Amendments to the Drawings

REMARKS/ARGUMENTS

Serial No.: 10/804,890 Filed: 03/18/2004

For: Ion Implanter and Method of Preventing ... A Target Wafer

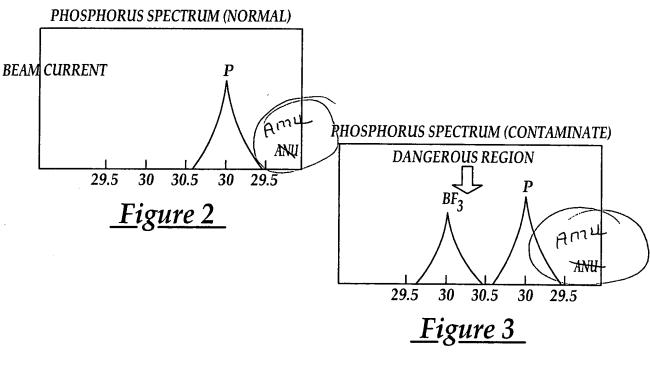
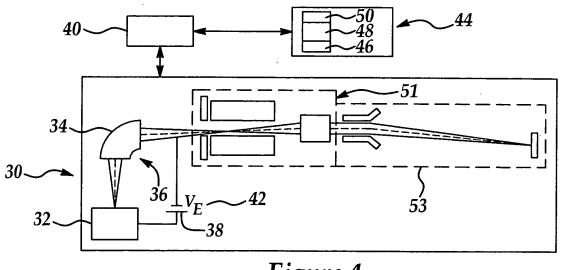
The attached sheet of drawings includes changes to FIGS. 2 and 3. This sheet, which includes FIGS. 1-4, replaces the original sheet including FIGS. 1-4. FIGS. 2 and 3 of the drawings were amended to correct minor informalities. More particularly, the reference to atomic mass unit "AMU" was changed from "ANU" to "AMU" in both FIGS. 2 and 3.

Figures 2 and 3 were amended to correct the label from "ANU" to "AMU" referring to atomic mass unit.

FIGS. 2 and 3 of the drawings were amended to correct minor informalities. More particularly, the reference to atomic mass unit "AMU" was changed from "ANU" to "AMU" in both FIGS. 2 and 3. Approval of the drawing changes as provided in the Appendix is respectfully requested.
